**LAKE HAVASU CITY**  
**LAKE HAVASU CITY, ARIZONA**

**ADDENDUM NO. 1**

**TANK REHABILITATION**  
**Project No. WT7440**

**DATED: NOVEMBER 14, 2016**

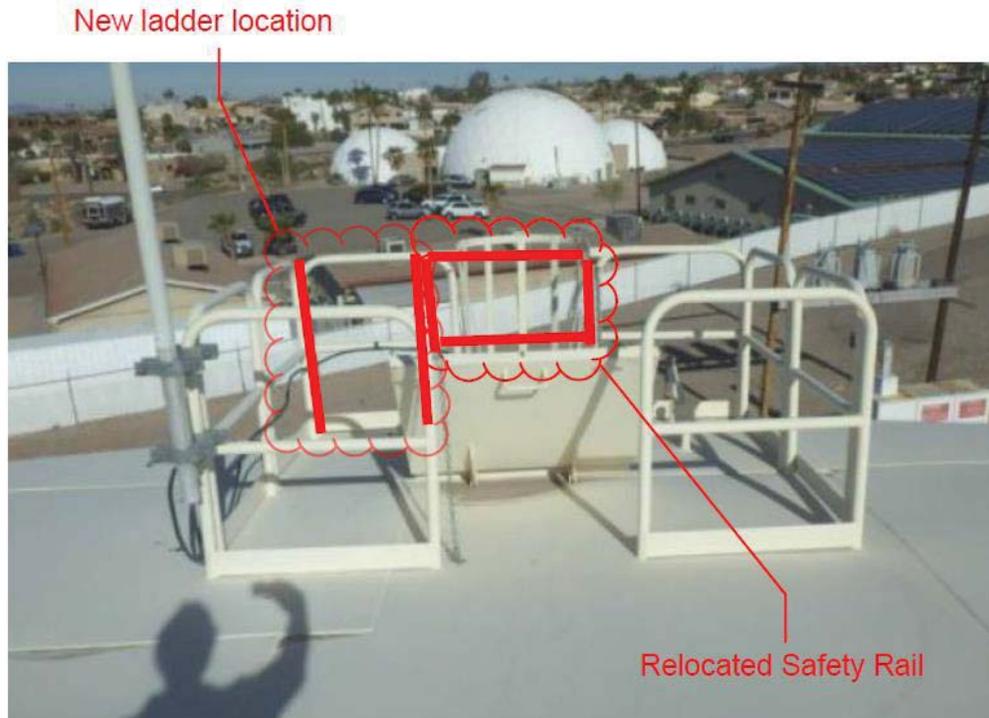
8. **Question:** *“What kind of containment screens need to be used for spray applications?”*

**Answer:** Specifications do not require specific type of containment. Ensure containment meets requirements of specification sections 01210; 4.3.; 4.; section 09950; 1.3.; M.; section 09950; 2.4.; C.; 5.; section 09950; 3.7; B.; and section 09951.

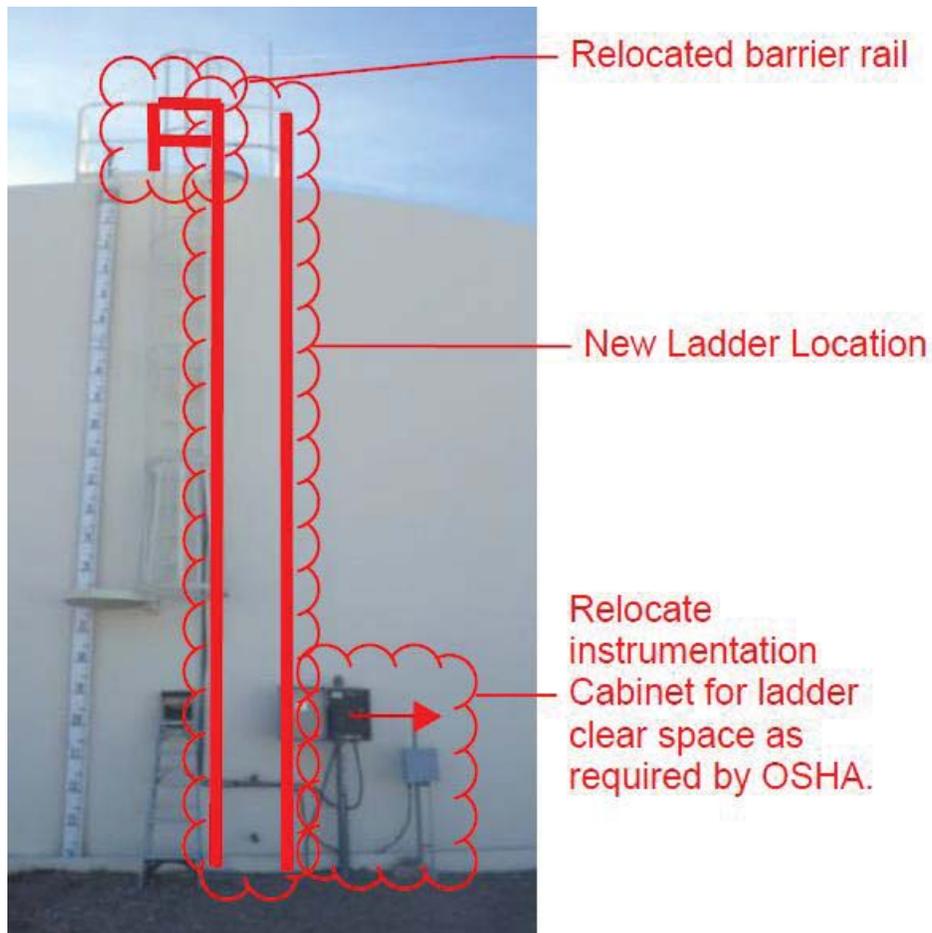
10. **Question:** “Do existing ladders need to be re-located to comply with OSHA requirements”

**Answer:** Ladder at tank S-1C-25 will need to be removed and re-installed at an offset from the existing ladder location to provide an applicable clear landing at the top of the ladder. Safety rail will need to be relocated to allow for new ladder location. Contractor to include this work as part of the base bid for ladder removal and replacement, and include a submittal reflecting the proposed relocated ladder and rail, including details. Proposed ladder location is to be approved by the Engineer prior to construction.
